**DESIGN AND CONSTRUCTION GROUP
THE GOVERNOR NELSON A. ROCKEFELLER
EMPIRE STATE PLAZA
ALBANY, NY 12242**

ADDENDUM NO. 1 TO PROJECT NO. 45545

**CONSTRUCTION WORK
RELOCATE STATE POLICE EXHIBIT
NEW YORK STATE FAIRGROUNDS
581 STATE FAIR BOULEVARD
SYRACUSE, NY 13209**

February 16, 2017

1 ELECTRICAL SITE PLAN
SCALE: 1"=10'-0"

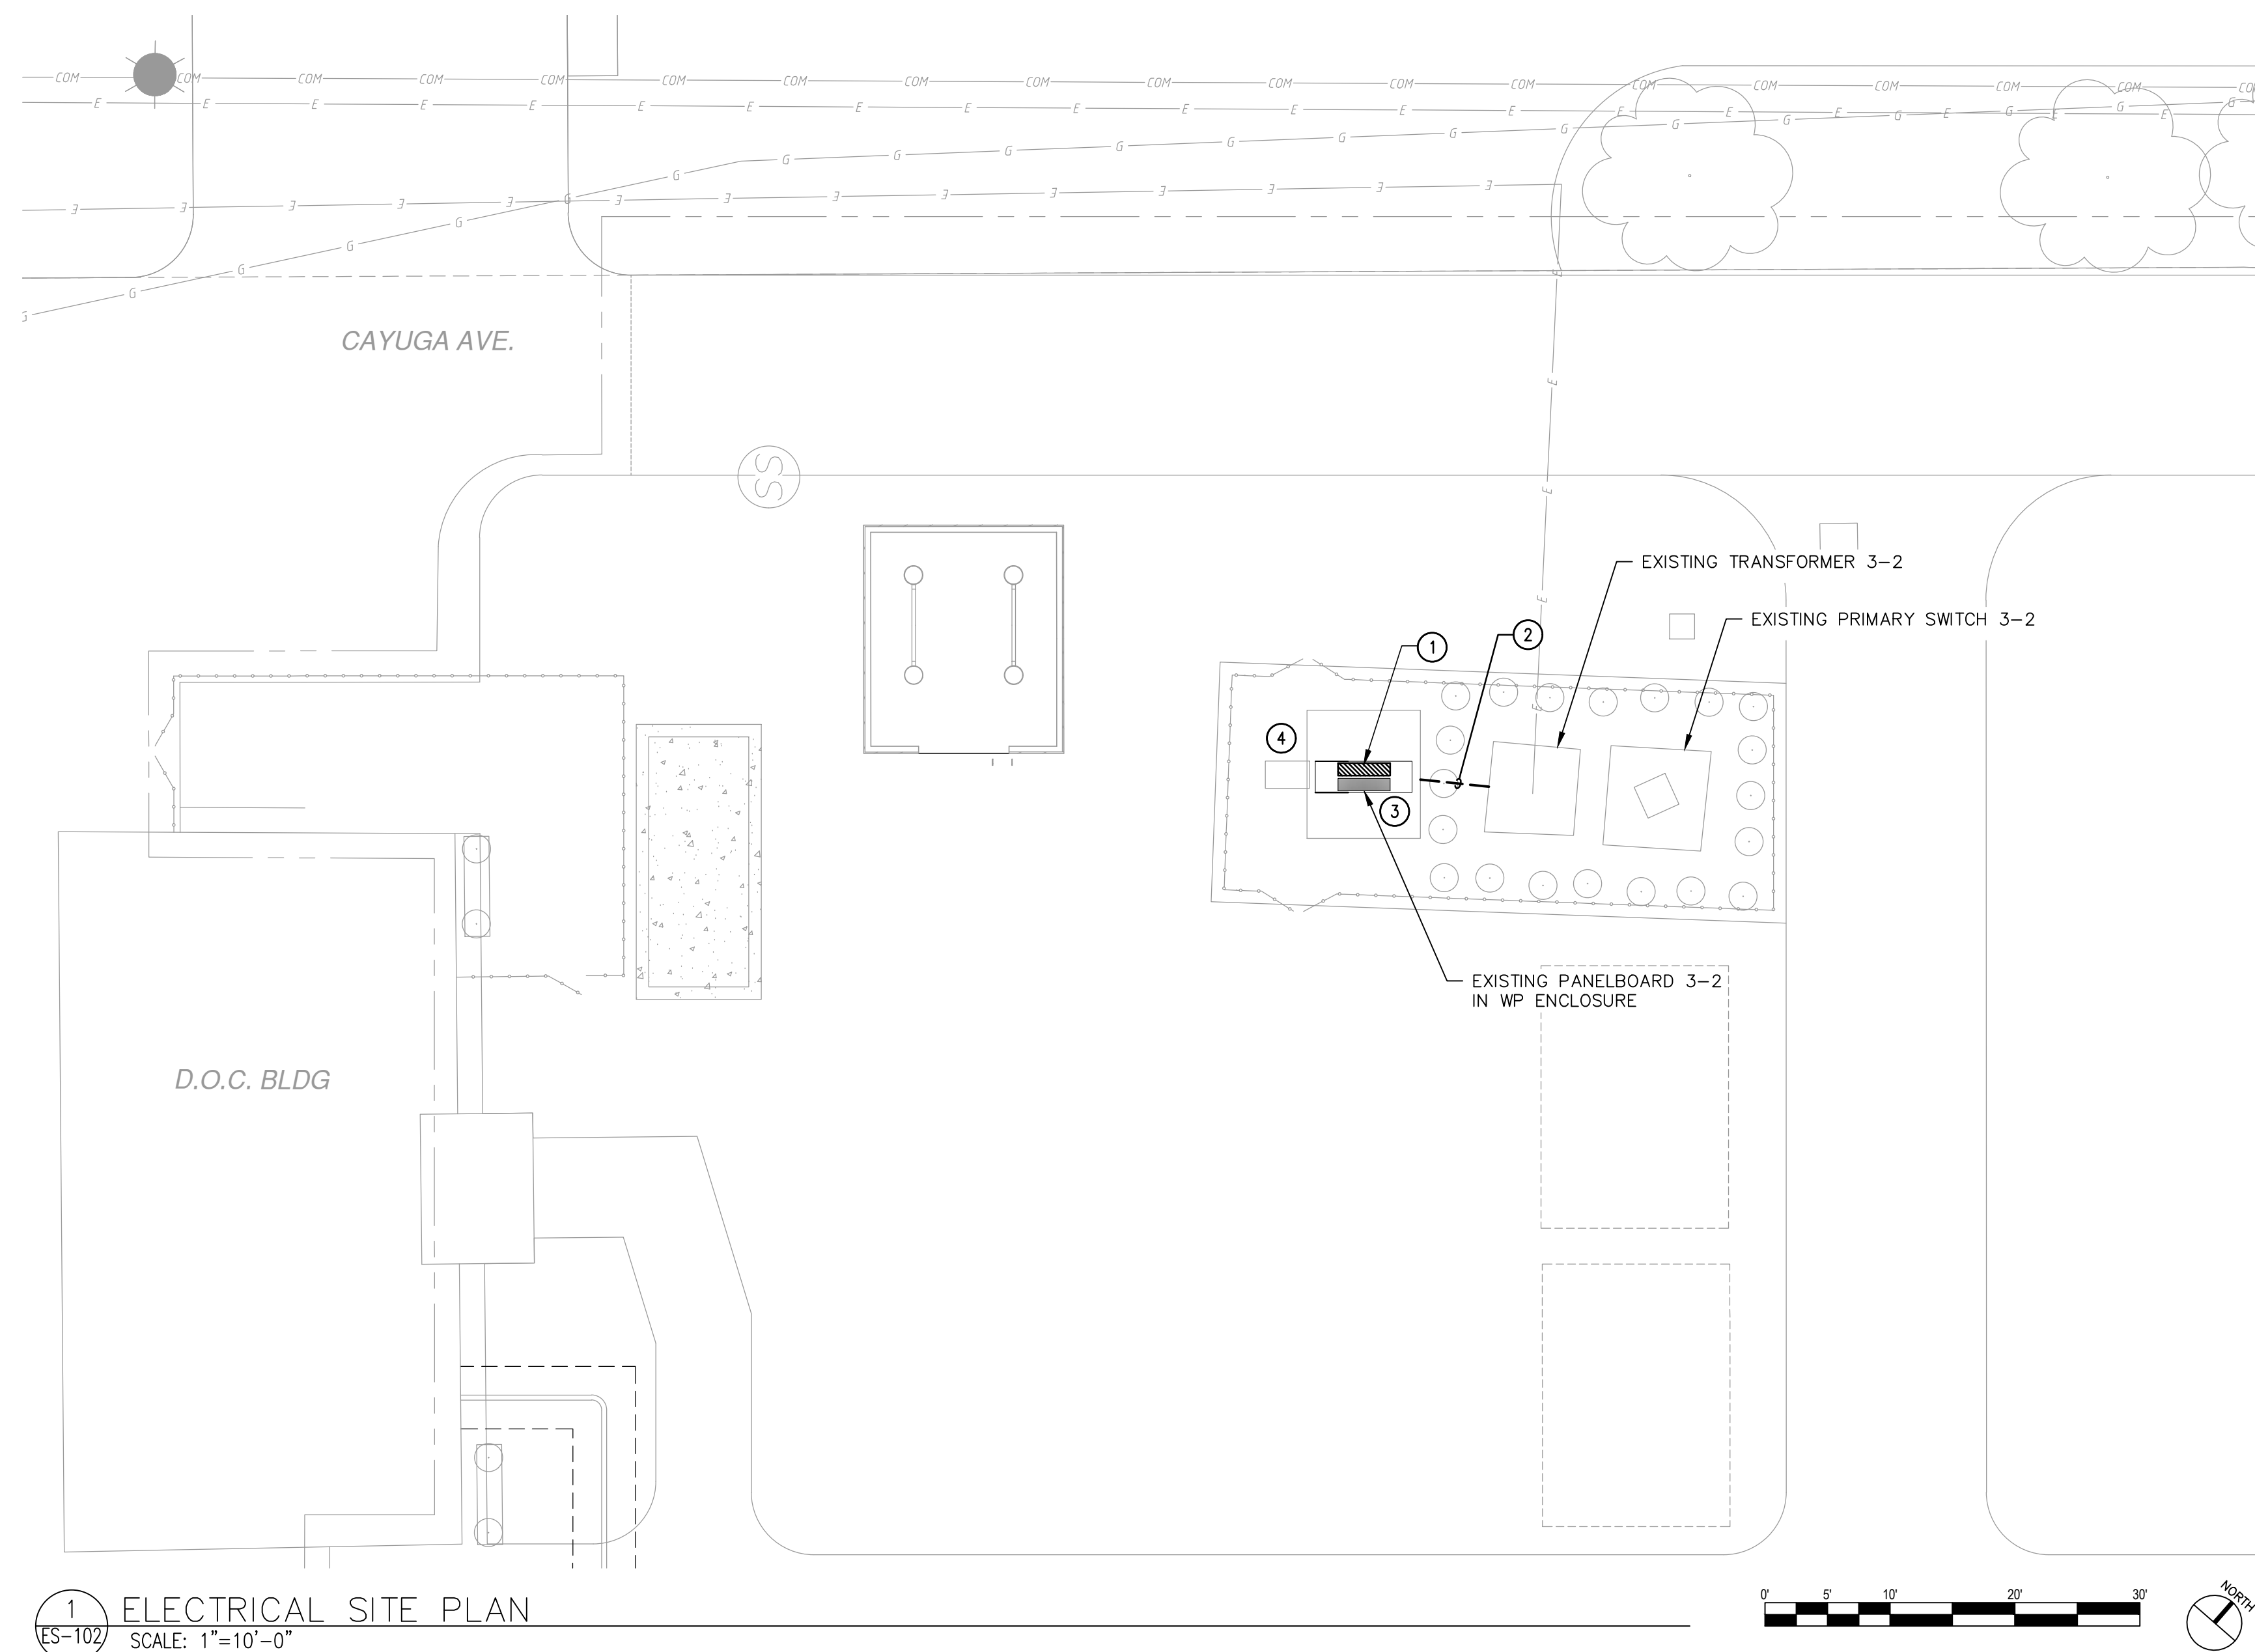
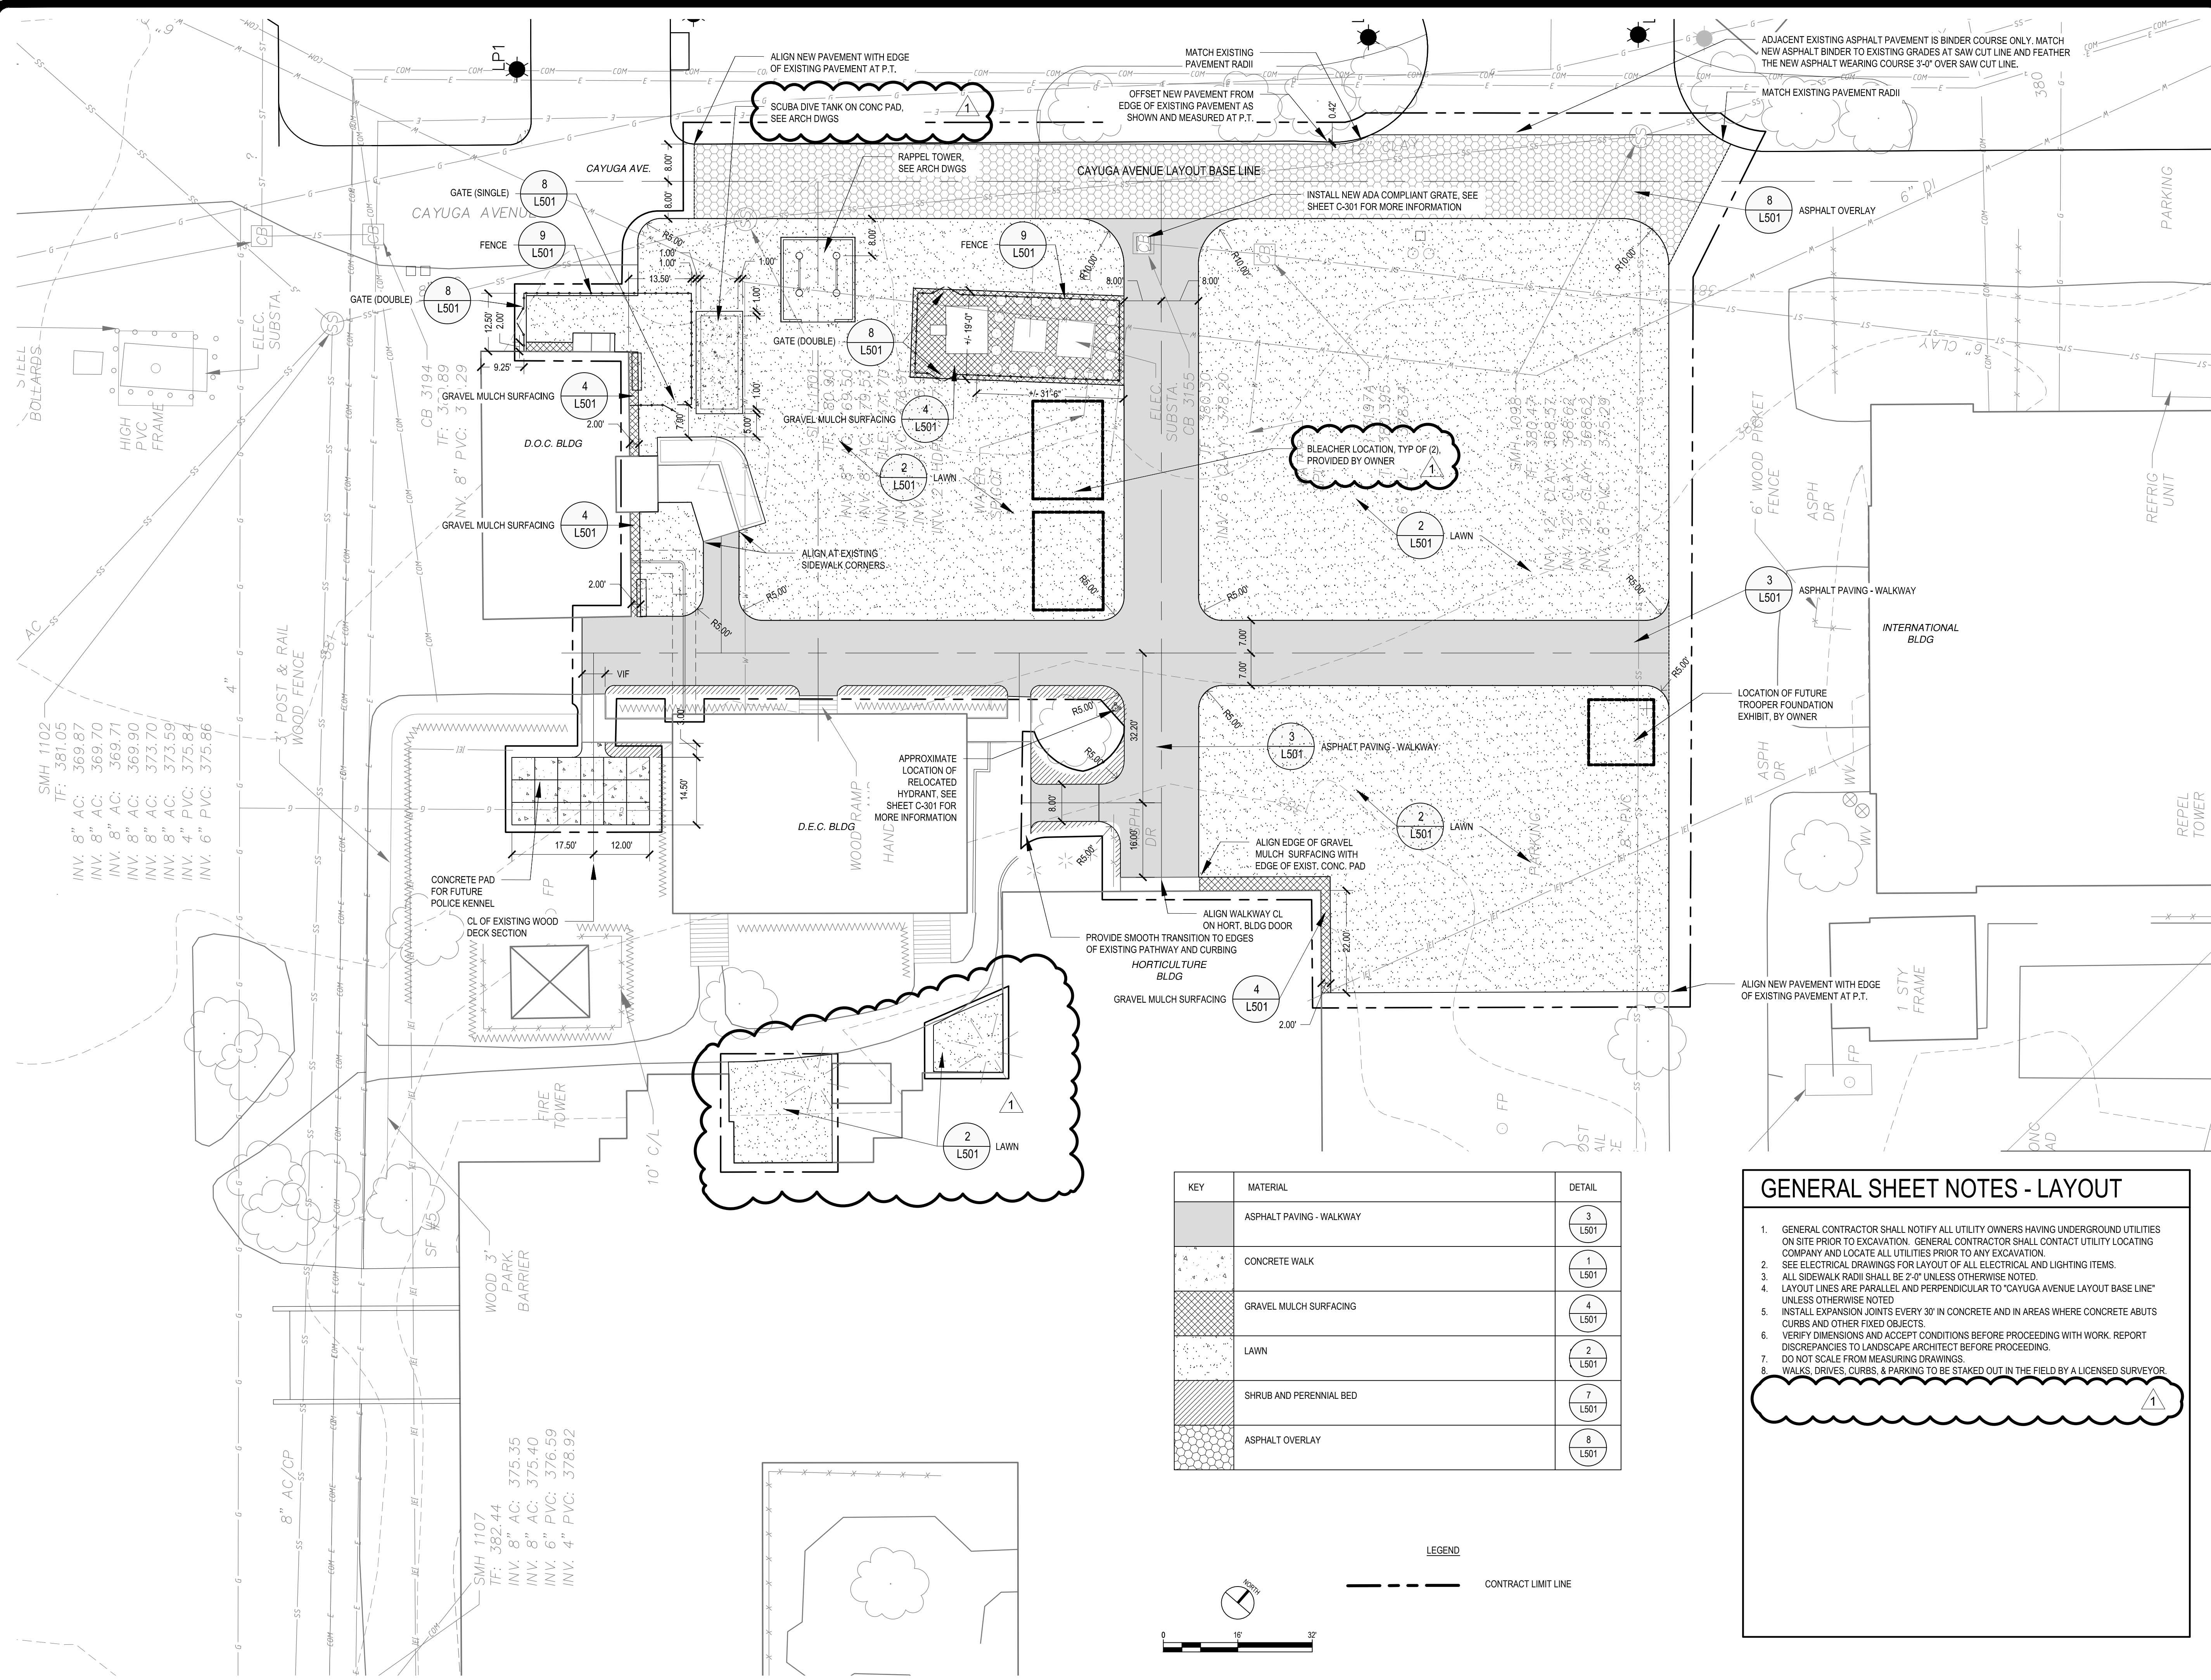
5. DRAWING ES-102, ELECTRICAL SITE PLAN: Add to the Construction Drawings the drawing noted "2/16/17 Addendum #1" that accompanies this Addendum and modify the Cover Sheet accordingly.

1. PROVIDE 800 AMP PANELBOARD "3-2A" PER PANEL SCHEDULE THIS SHEET. INSTALL PANELBOARD IN EXISTING WP ENCLOSURE ON MIDWAY SIDE. EXISTING PANELBOARD 3-2 IS INSTALLED IN ENCLOSURE ON THE D.E.C. SIDE.

2. PROVIDE 2-4" CONDUIT FROM EXISTING TRANSFORMER SECONDARY COMPARTMENT TO PANELBOARD ENCLOSURE TO SERVE PANELBOARD 3-2A. PROVIDE 4-600 KCMIL, 3/0 GROUND IN EACH CONDUIT. EXCAVATE AS REQUIRED AROUND TRANSFORMER PAD AND PROVIDE CONDUIT OR PROVIDE RGS LB FITTINGS FROM SECONDARY COMPARTMENT.

3. PROVIDE LOUVER AND FILTER FOR EXISTING ENCLOSURE. LOUVER (15.31" H X 9.5" W X 0.43" D, BY SAGINAW CONTROL & ENGINEERING #SCE-AVK812 AND FILTER #SCE-FLT812). PROVIDE ONE LOUVER/FILTER ASSEMBLY PER DOOR, AND ONE LOUVER/FILTER ASSEMBLY ON SIDE WALL.

4. EXISTING WIREWAY WITH FEEDERS TO GROUND PANELS. RELOCATE AS DIRECTED 4-200 AMP FEEDERS FROM PANELBOARD 3-2 TO PANELBOARD 3-2A. UPDATE PANEL SCHEDULE OF PANELBOARD 3-2.
